8. Well Name and No.
GOLD RUSH 30 FEDERAL 49. API Well No.
30-015-28872-00-S110. Field and Pool or Exploratory Area
NASH DRAW11. County or Parish, State
EDDY COUNTY, NM**SUBMIT IN TRIPLICATE - Other instructions on page 2**

PROPOSED WELLBORE

**Permanent Abandonment of Federal Wells
Conditions of Approval**

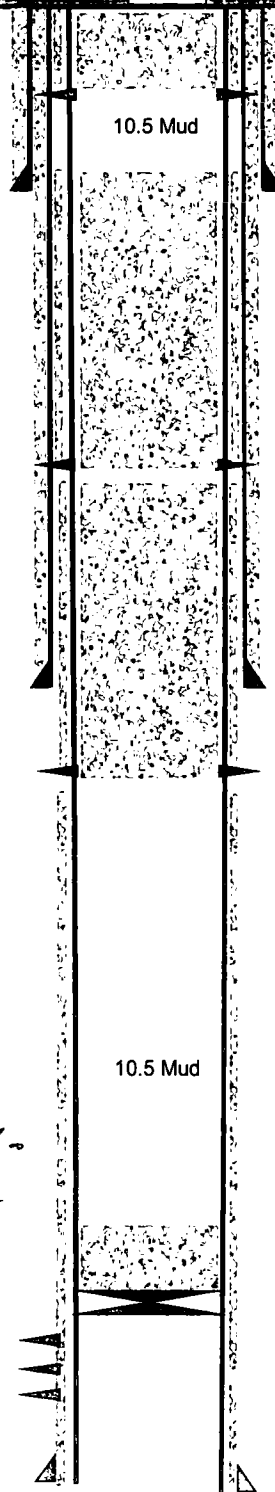
** BLM REVISED ** BLM REVISED ** BLM REVISED ** BLM REVISED ** BLM REVISED **

1" to Surf from 300'

TOC @ 3760
 CMT log in OCD well file
 TS

Proposed:
 1. Perf at 140'.
 2. Pump 35 sx Cl C in/out 140'-surface.
 3. Cut WH off 3' BGL. Set dry hole marker.

Proposed:
 1. Perf at 2000'.
 2. Pump 175 sx (1770') Cl C in and out 2000'-230'.

Proposed: Brushy 5872
 1. Perf at 3700'.
 2. Pump 175 sx (1770') Cl C in and out 3800'-1930'. Tag.

Proposed:
 1. Set CIBP at 7000' — 6504
 2. Spot 25 (250') Cl C @ 6750'-7000'. WOC & Tag. Circ
 10.5 salt gel. 6504-6254
